Dresden Station
Chapter 11 Change Summary
ODCM Revision 1.4, May 1998

Revision 1.4
May 1998

CHAPTER 11
RADIOLOGICAL ENVIRONMENTAL MONITORING PROGRAM
TABLE OF CONTENTS

FIGURE 11-1

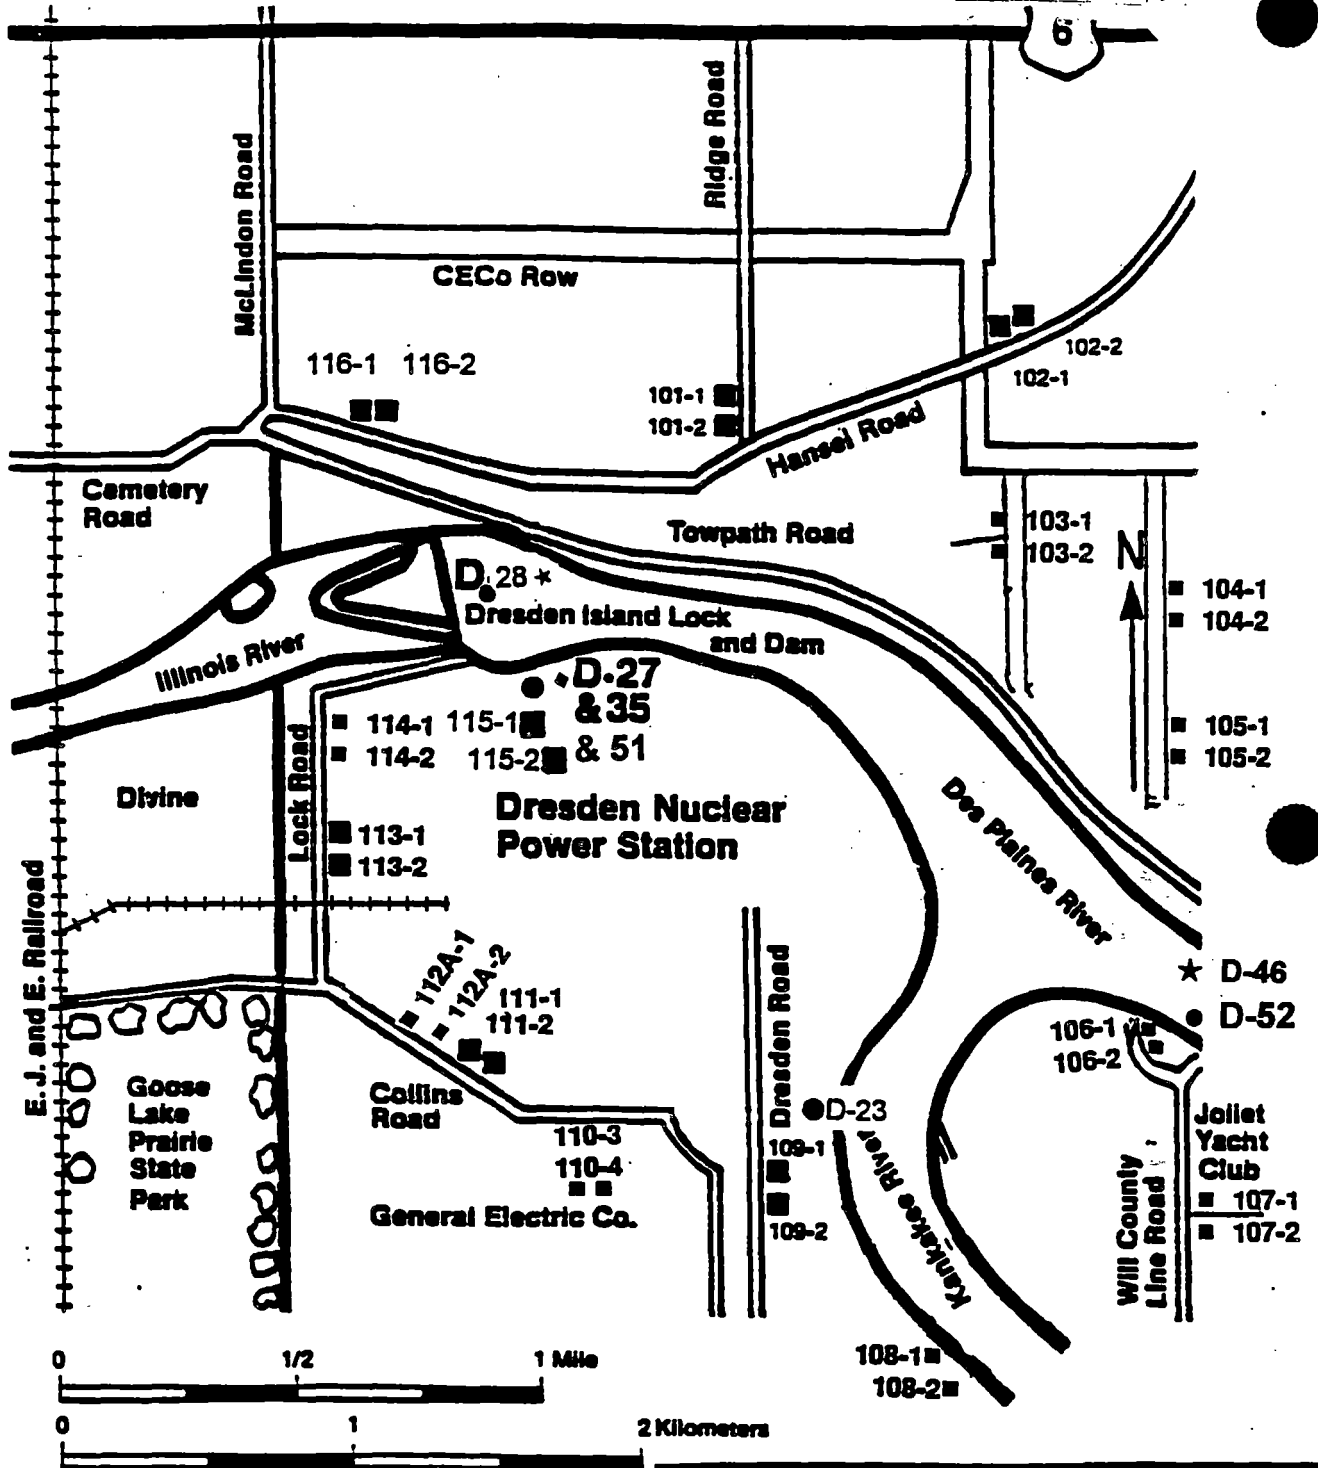
<u>Page</u>	<u>Change Description</u>
11-i	Updated the revision number, date and file designator.
11-2	Added air sample location D-53 and a notation that D-06 will be deleted once D-53 operational status is established.
11-9	Added D-53 to Figure 11-1 and moved number designator for D-7. (Actual sample location for D-07 did not change.)
